N.E.CO. SINGLE-COIL COIN RELAY
MAINTENANCE

1.01 This addendum is issued to expand the scope and modify the rating of Section 476-202-520, Issue 1. In ink or red pencil, write "See Addendum" to the right of the title on that section, and file this addendum ahead of it in the practices binder.

Figure 2. Coin Relay Contact Spring Assembly and Schematic.

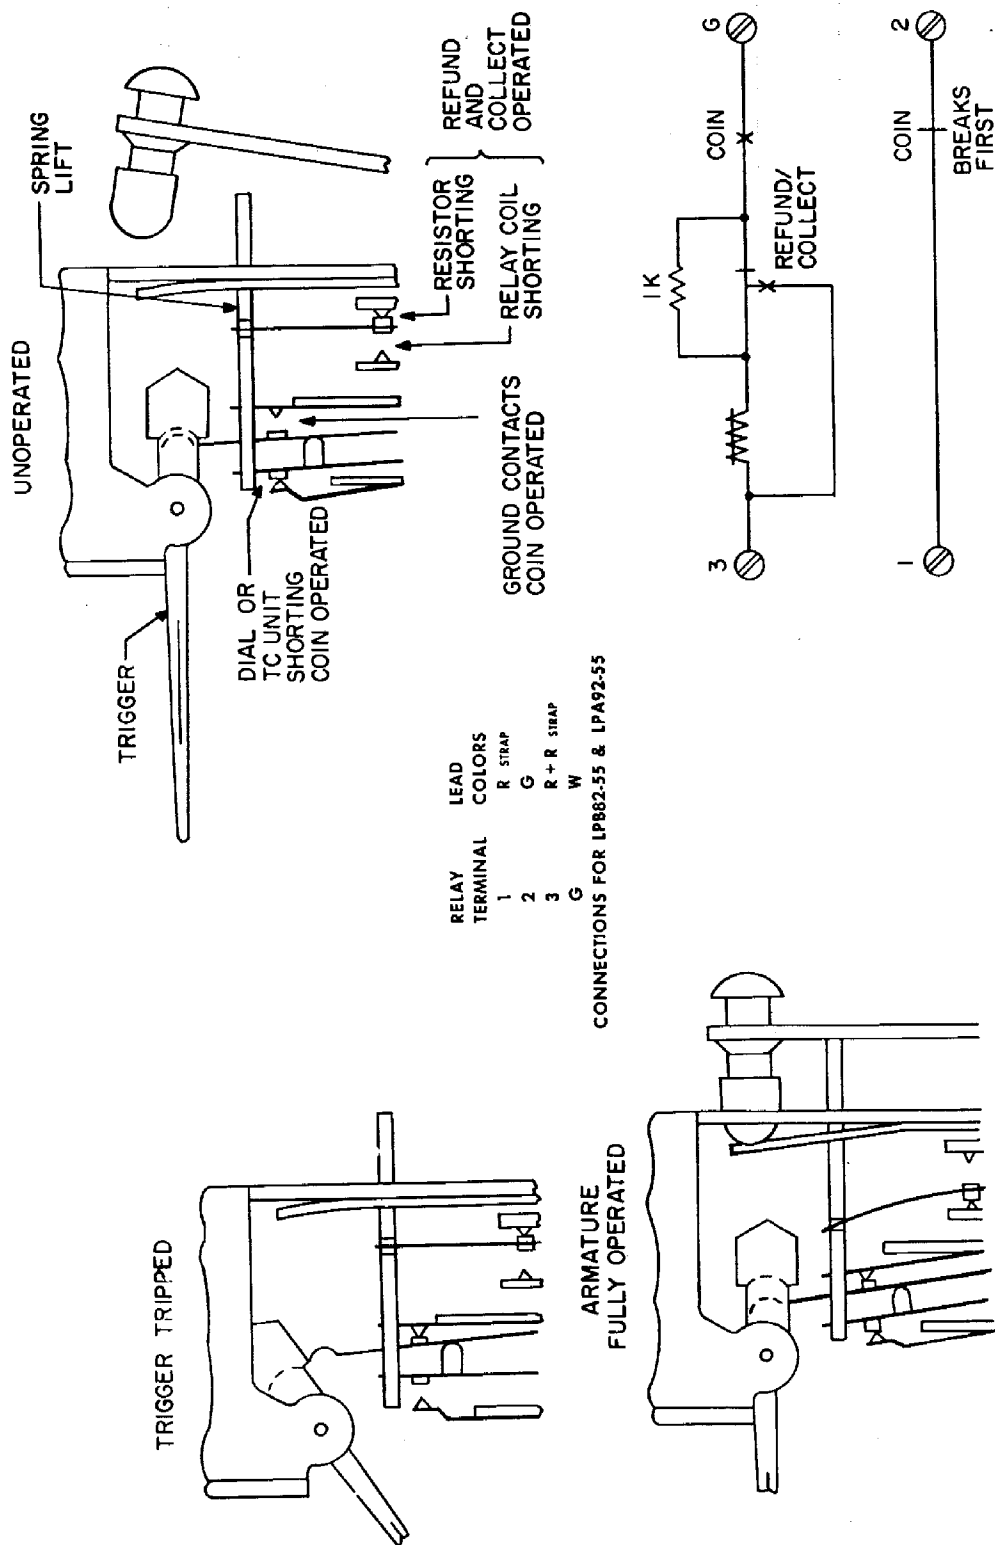
the P10E786 relay and P10E755 hopper specified in Figure 5 the A.E.Co. equivalents are relay P-60702 and hopper P-60703. Dust cover P10E783, mentioned in Paragraphs 2.01, 3.01 and 4.03, is the same as A.E.Co. dust cover P-51942. The P10E810 Sems fasteners and P10E752 hex head screws detailed in Paragraphs 4.01 and 4.03 are listed by A.E.Co. as upper coin relay mounting screw D-761037-A and lower coin relay mounting screw D-761036-A, respectively. Terminal G, referred to in Paragraph 2.02(2) and Figure 2, is designated as terminal 4 in the A.E.Co. assembly.

2.03 In factory-assembled coin telephone sets using the P-60701 relay and hopper, the green lead from transfer spring 5 is connected to relay terminal 1, rather than to terminal 2 as shown in Figure 2. The strap from relay terminal 3 is connected to relay terminal 2, rather than to terminal 1, and is made of brown wire rather than red.
